E.I. DU PONT DE NEMOURS & CO. (INC.)
MEDICAL PRODUCTS DEPARTMENT

A new DuPont xenon vial will be introduced to the medical user marketplace by the DuPont Medical Products Department.

As of April 24, 1989, customers will begin to receive DuPont Xenon-133 gas in vials manufactured from tubing stock instead of the current vial manufactured by a molding process. The only physical changes, as a result of this modification, is that the new vial wall thickness will be slightly less and the new gas volume will be 3 cc per vial rather than the existing 2 cc gas volume per vial.

RE: NDA #17-284
XENON Xe-133 GAS
SUPPLEMENT #S-006

DIMENSION SPECIFICATION COMPARISON

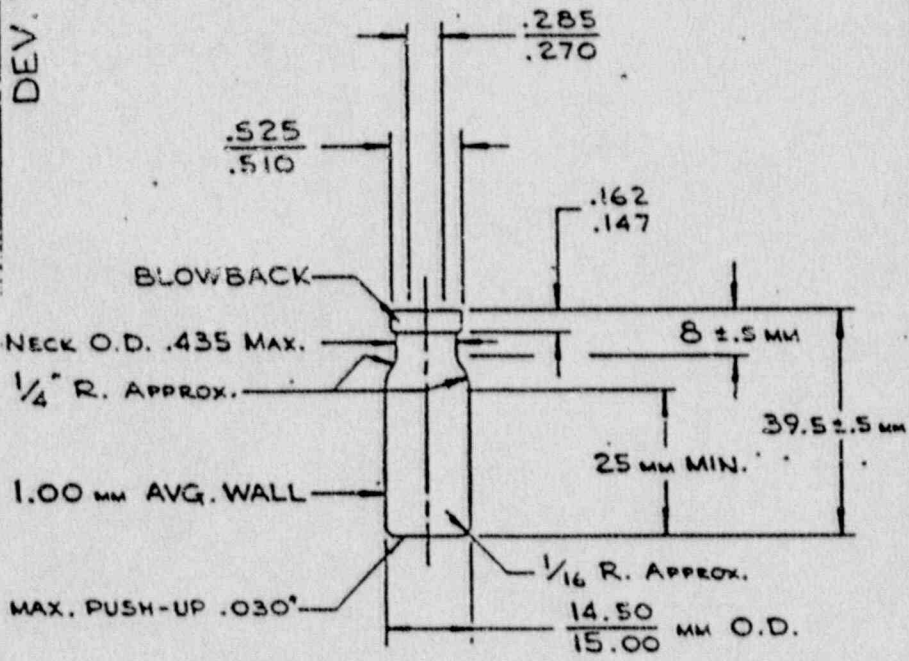
- The outside dimensions of the 3 cc vial and the 2 cc vial are substantially equivalent; with the range of the 3 cc vial dimensions falling within the specified tolerances of 2 cc vial dimensions. Please reference the attached Wheaton vial drawings and dimension specification comparison.
- The finished dimensions of both vials are identical and the finish is compatible with the current closure system.
- Xenon Xe-133 Gas is an inert gas with no glass adhesion characteristics. Accordingly, the increase in internal volume represented by the 3 cc vial would have no impact upon the identity, quality, efficacy, purity or strength of the drug product.

<u>3 cc Vial</u>	<u>2 cc Vial</u>
Diameter of mouth:	0.270" - 0.285"	0.270" - 0.285"
Diameter of lip:	0.510" - 0.525"	0.506" - 0.525"
Height of vial:	1.535" - 1.575"	1.532" - 1.594"
Diameter of vial body:	0.571" - 0.591"	0.563" - 0.625"
Height of lip:	0.147" - 0.162"	0.147" - 0.162"
